RFI #: 128
 Date: 5/29/2012
 Job: EB-02 Keller Springs Lofts
 Phone: 877-777-5115

CC: Heath Parnell (Jordan & Skala Engineers, Inc.)
 Subject: Corridor duct issues

RFI #: 133
 Date: 5/30/2012
 Job: EB-02 Keller Springs Lofts
 Phone: 877-777-5115

CC: Erik Eamshaw (Beeler Guest Owens Architects)
 Subject: Supply and Return Air Grills on All Floors

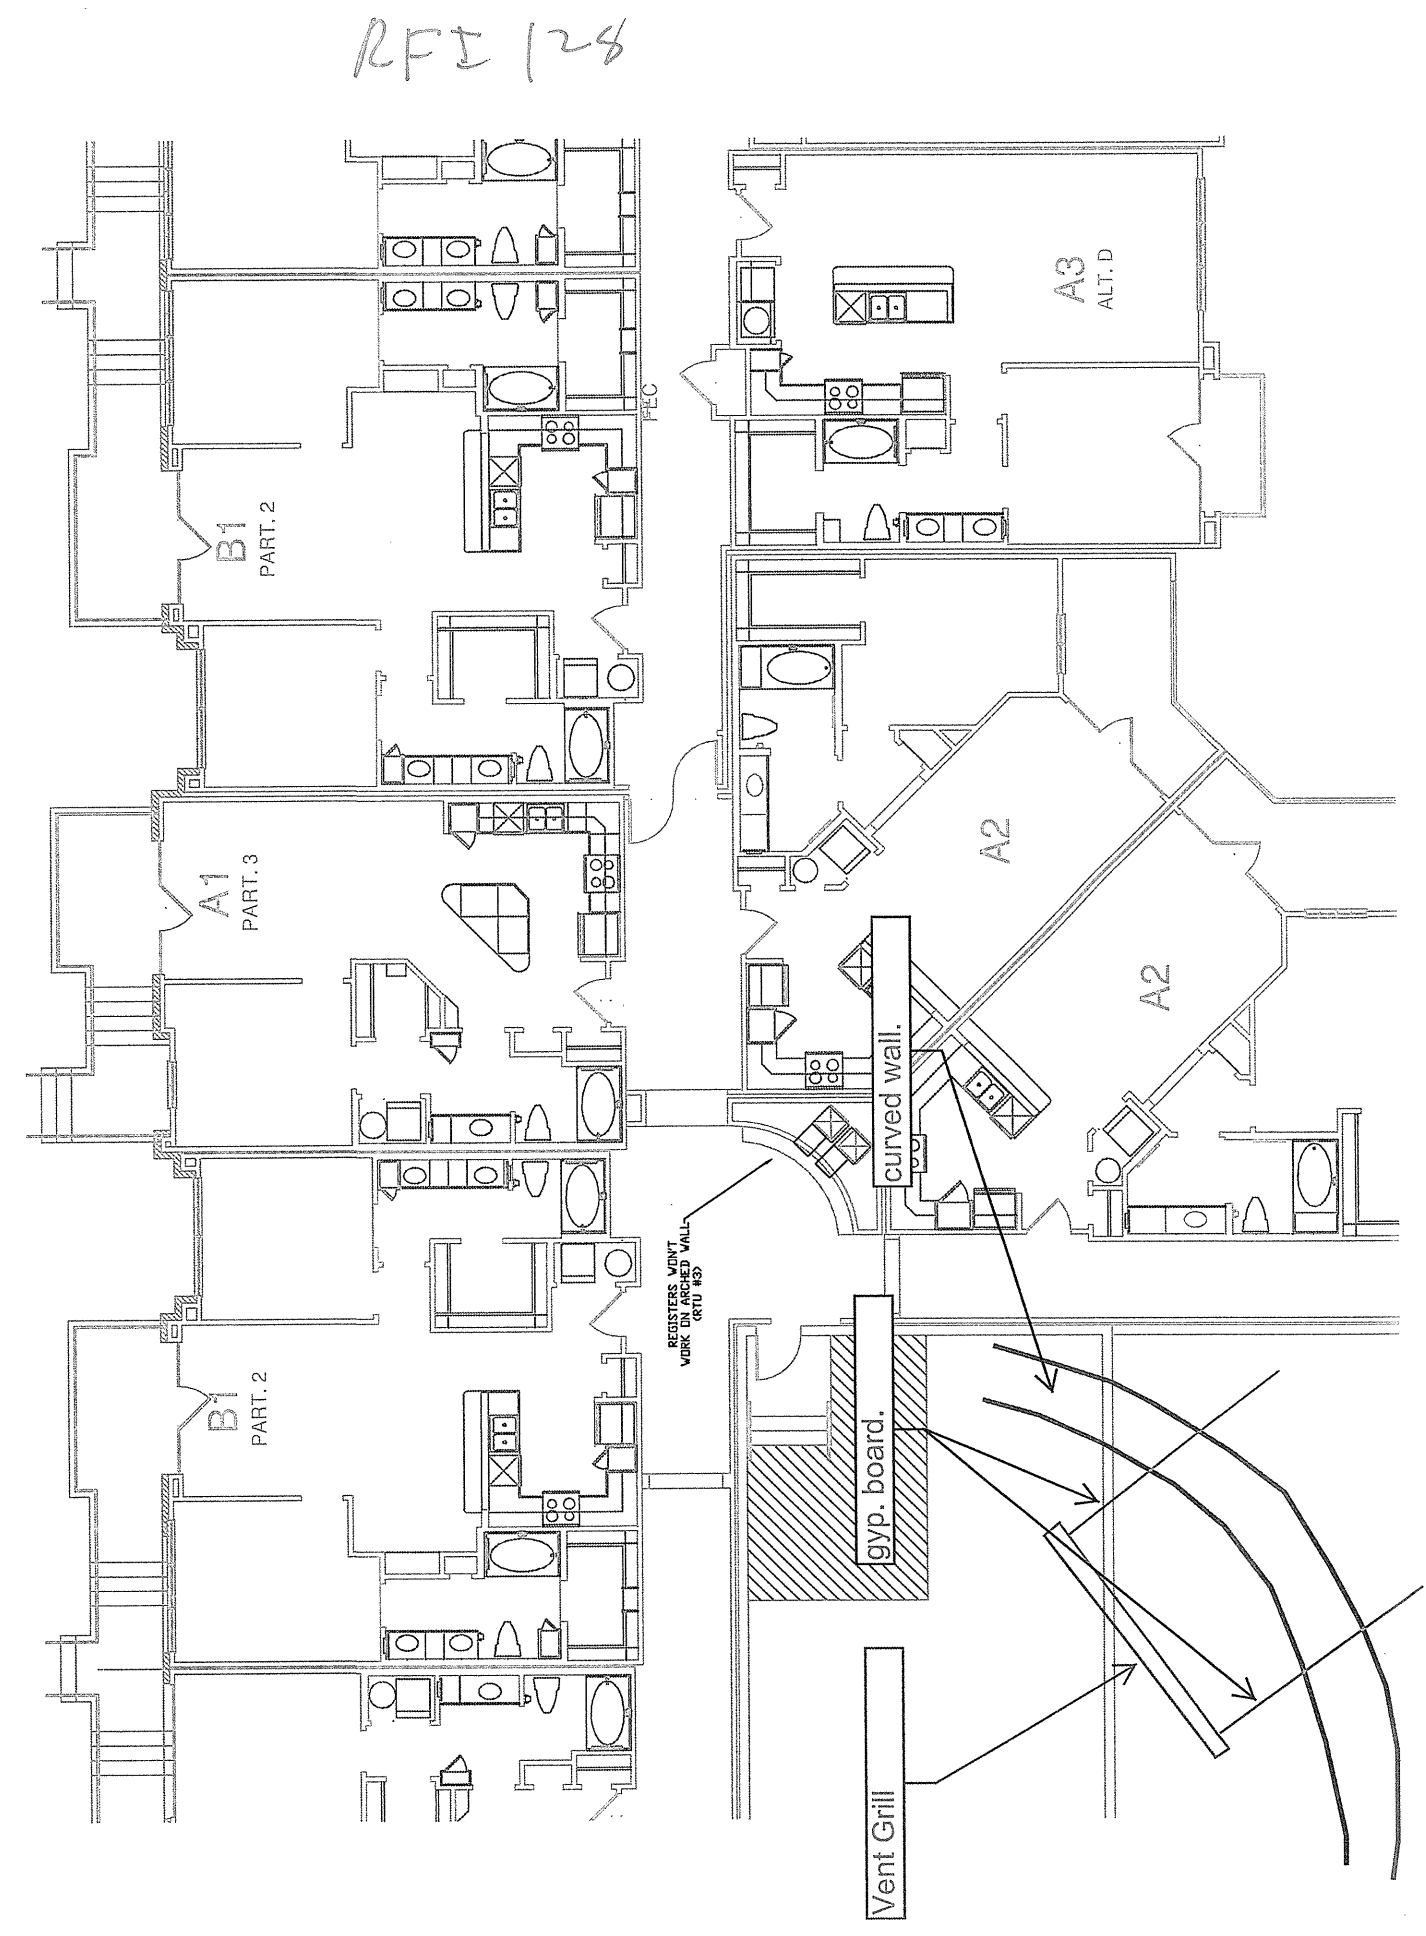
Request: Date Required: 6/5/2012
 We are laying out the corridor duct that run through the shafts from the roof and have found some conditions that need addressing. The attached drawings and the following narrative should clarify these items:

- The curved corridor wall at section C needs to be flat or have flat areas to mount the grilles.
- The corridor wall at the shaft works well on floors 2-4 but changes on the first floor and creates a problem. Suggest using the upper floor configuration on the first floor.

- For air grills being installed in curved walls, I recommend popping the grill 2-3 inches off of the wall to allow for gypsum board to wrap around the grill where it protrudes from the wall.
- The upper floors will not work due to the ramp and handrail. See next pages for possible solution.

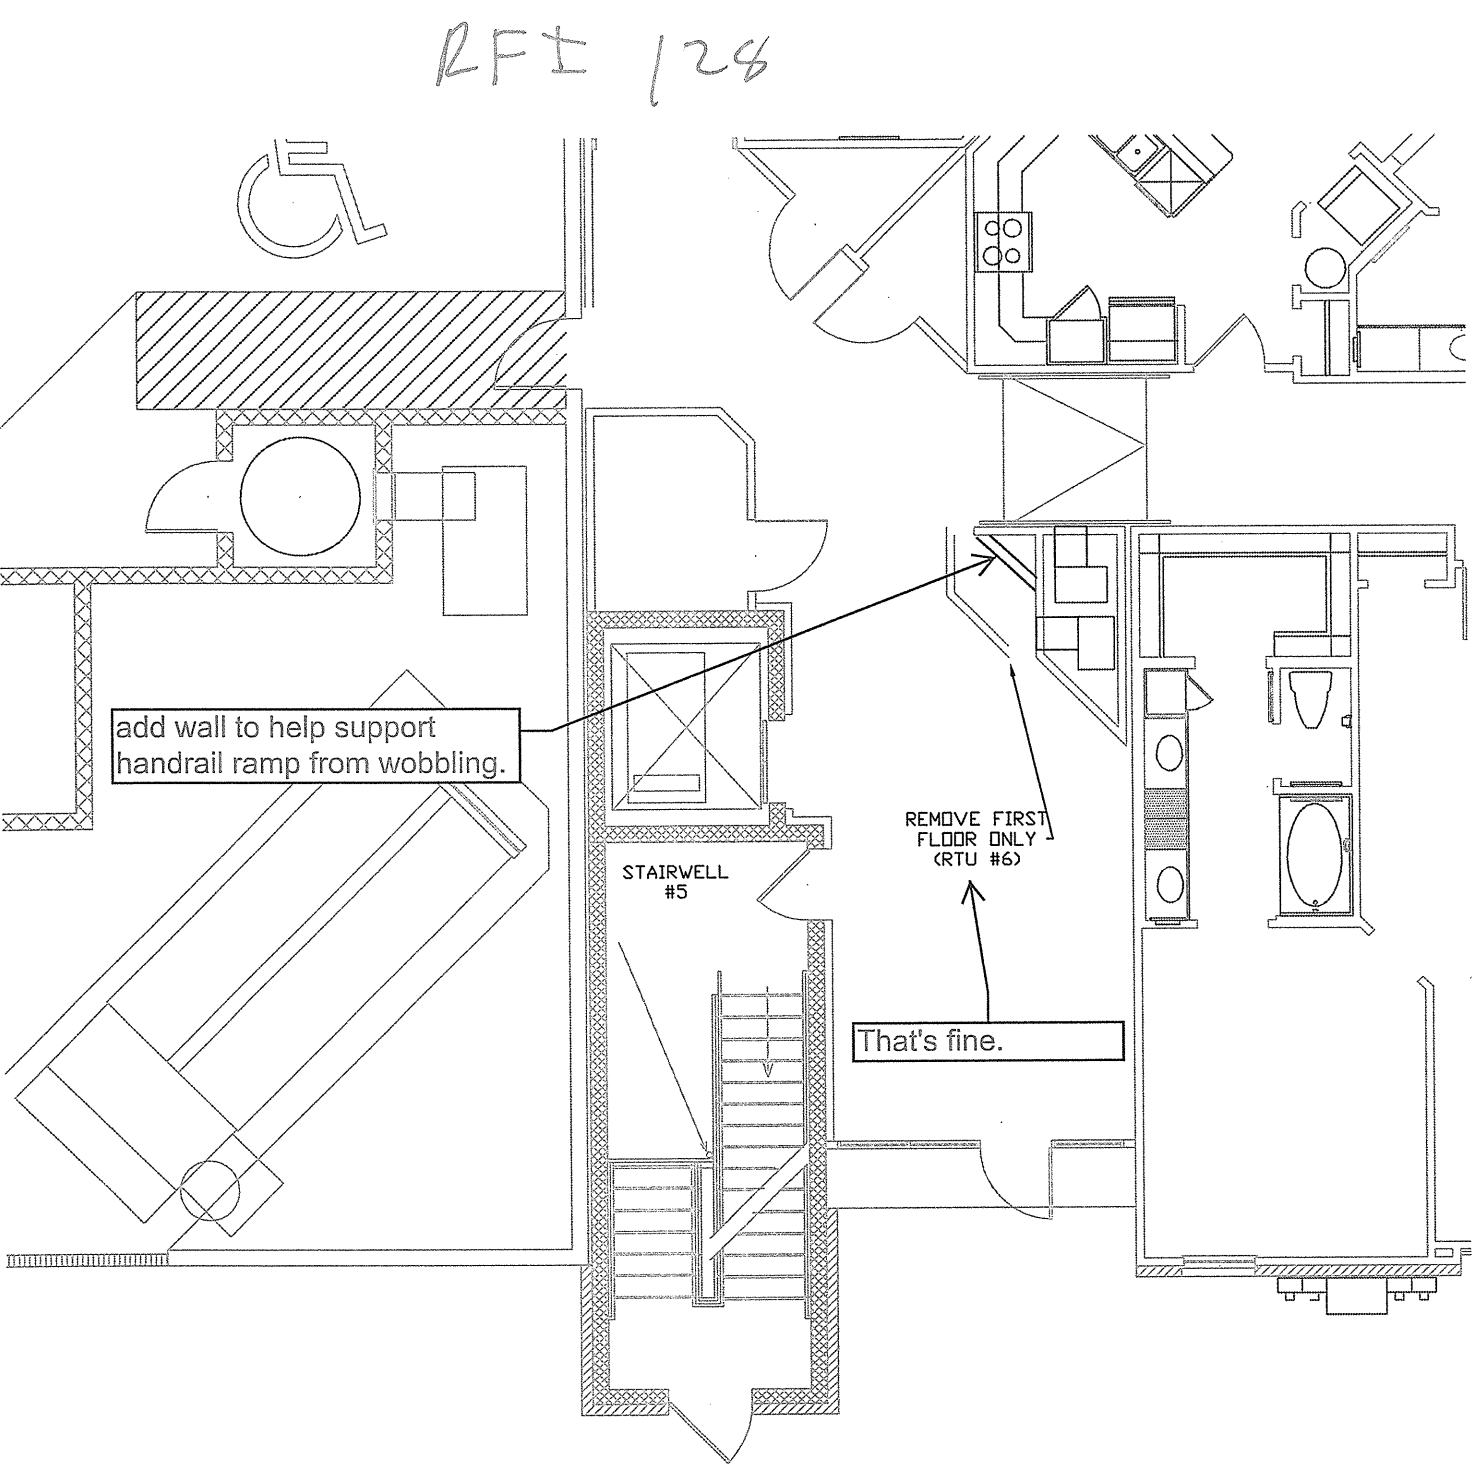
Request: Date Required: 6/7/2012
 The supply and return air grills will not work on the curved walls on each floor as shown on A3.1C, A3.2C, A3.3C and A3.4C. A portion of the wall will need to be straight for the grills.

Based on correspondence between Ryan Faulds at BGO and David Miller with Embrey via email on Thursday July 12th, the walls will be updated to provide flat areas for the supply and return grilles.
